Millstone Nuclear Power Station, Unit No. 2
Reply to Request for Additional Information
Related to NRC Bulletin 2001-01

Reply to Request for Additional Information
Related to NRC Bulletin 2001-01

Figure 1 Location of UT indications in Nozzle 21 from 2R14 Inspection

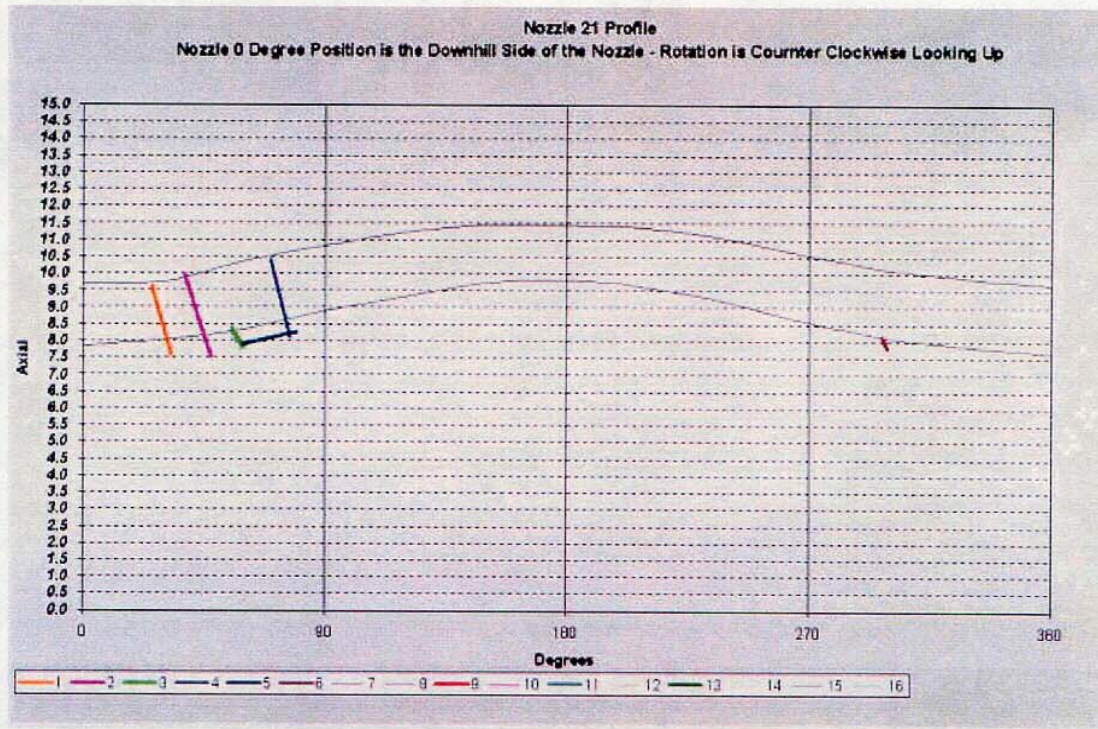
2. *The information in the three tables states that the location of each of the indications found is "OD downhill". The staff requests more specific information regarding the locations. If possible, please provide the information similar to that provided by in Figure 8 through 12 of the Root Cause Analysis Report for Davis-Besse dated April 18, 2002. These Figures are shown on the NRC website at:*

See Figure 1 through 3 on the following pages:
